SUBJECT: PRE-BID MEETING MINUTES/ADDENDUM 1 FOR DE00161 – B-5940,  
46485.3.1, Rehabilitate Bridges #84 and #91 on Glenwood Ave. (US 70) over  
Crabtree Creek in Wake County

MEMORANDUM TO PROSPECTIVE BIDDERS AND MEETING ATTENDEES

## **CONCRETE WASHOUT STRUCTURE:**

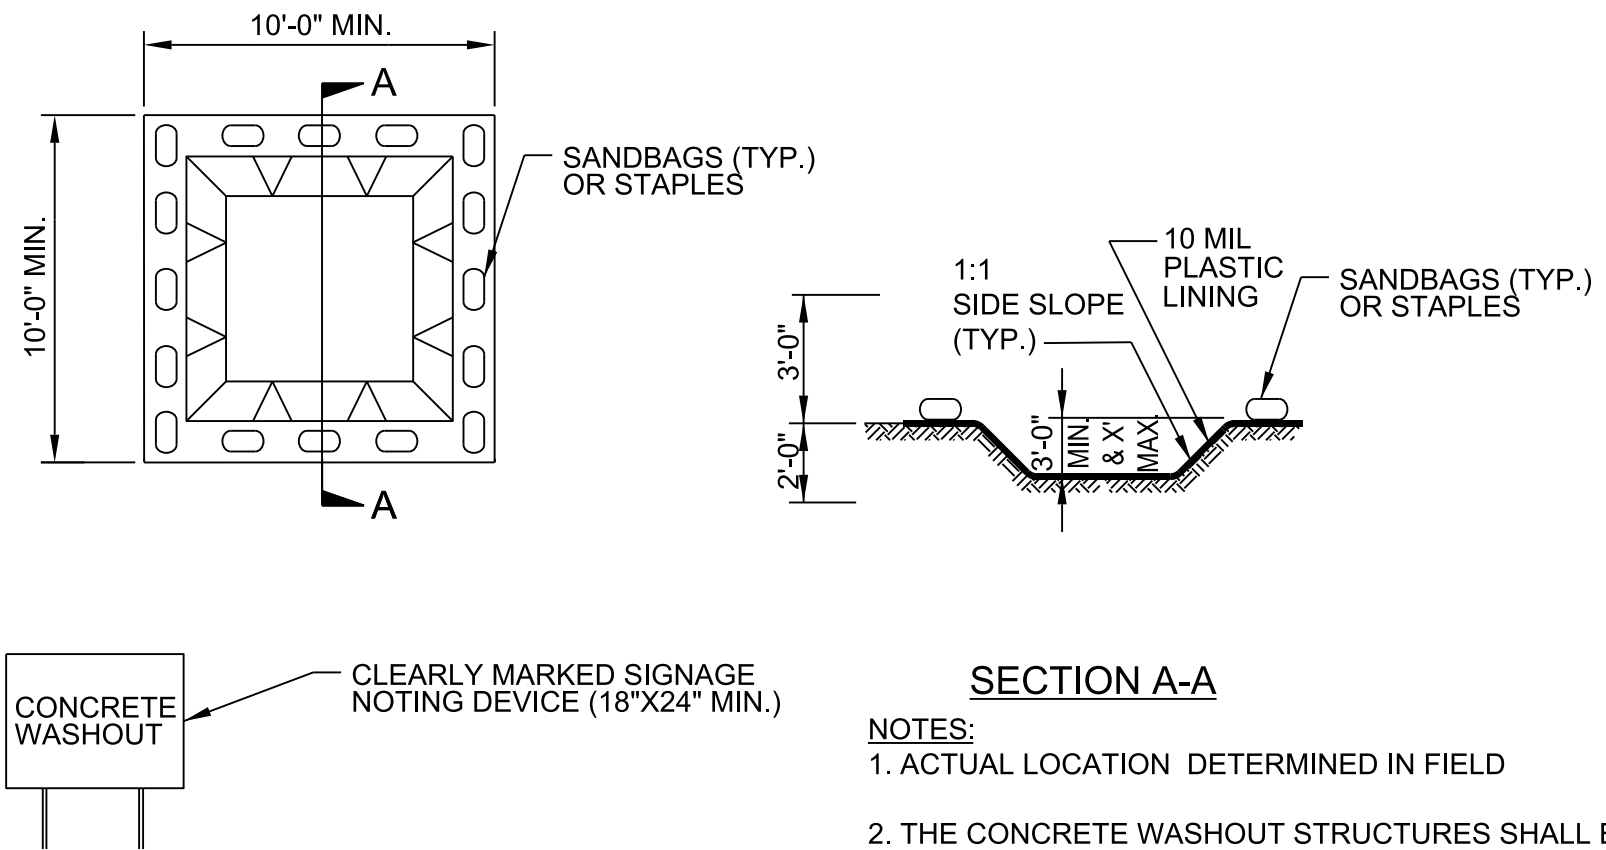
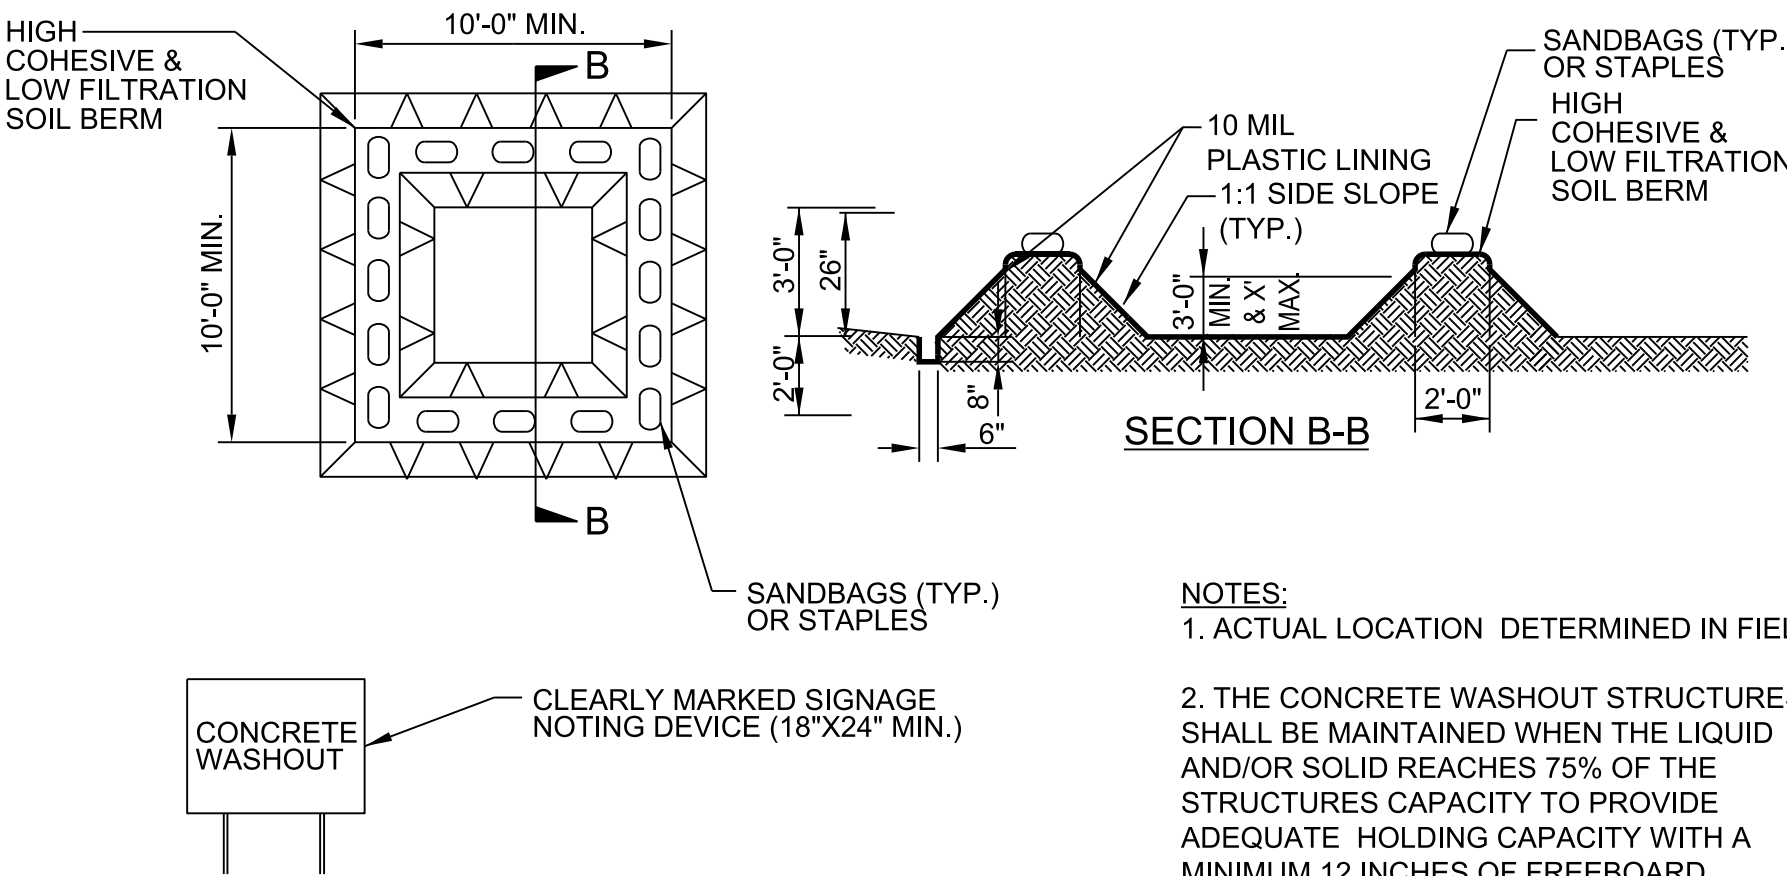
Page 26 Erosion and Sediment Control/Stormwater Certification requires a Level II Erosion Control Supervisor. *After the meeting it was determined that this is NOT required for this project because there are no land disturbing activities. Please strike through the Erosion and Sediment Control/Stormwater Certification provision found on Page 26 of the proposal. In addition, it was determined that Concrete Washout Structures will be required for this project. The Concrete Washout special provision and detail drawing as well as revised bid sheets have been attached for use in bidding this project.*
